Subject: Notice of Violation No. R9-2013-0148, Torrey Hill Unit 19, NPDES Order No. 2009-0009-DWQ

NOTICE OF VIOLATION No. R9-2013-0148

Torrey Hills Unit 19 PIN: 9 37C362854: carias

FACILITY INSPECTION REPORT

Figure 6. West perimeter; trash

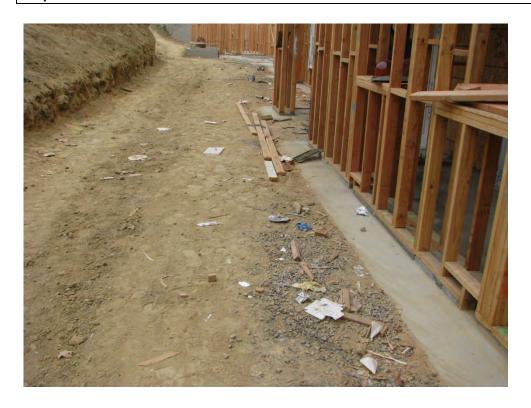
- 1. The site was littered with cigarette butts, trash, and debris throughout. Mr. Do was unaware of any specific dedicated trash area (See Figures 1-7).

- 1. Overall the site lacks adequate housekeeping. The site requires an improved method for dealing with trash and construction debris.
- The site requires erosion control and adequate sediment control BMPs. All slopes require improved soil stabilization such as hydroseed, bonded fiber matrix, or erosion control blankets.
